**Re: Albuquerque Collegiate Charter School**  
**9001 Sunset Gardens Rd. SW**  
**Albuquerque, NM 87121**  
**Traffic Circulation Layout**  
Engineer's Stamp 11-11-25 (L09-D032)

Based upon the information provided in your submittal received 11-11-25, the above referenced plan cannot be approved for Building Permit until the following comments are addressed:

FIGURE 7.4.115 Bicycle Parking Stall Layout Options

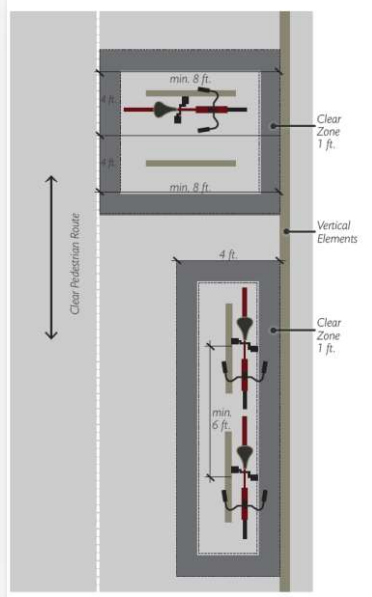
20. Per the DPM, a 6 ft. wide ADA accessible pedestrian pathway is required from the public sidewalk to the building entrances. It appears this may be provided. Please call out the pathway and provide design details.
21. Per DPM, a 6 ft. wide ADA accessible pedestrian pathway is required from the ADA parking stall access aisles to the building entrances. See comment #19 and provide additional details.
22. Ensure that the minimum 18 foot length for standard parking does not include curb.
23. Provide bicycle parking stall design details. Bicycle parking spaces shall be located, sized, and constructed as required by IDO.
24. Bicycle racks shall be sturdy and anchored to a concrete pad.
25. A 1-foot clear zone around the bicycle parking stall shall be provided.
26. Bicycle parking spaces shall be at least 6 feet long and 2 feet wide.
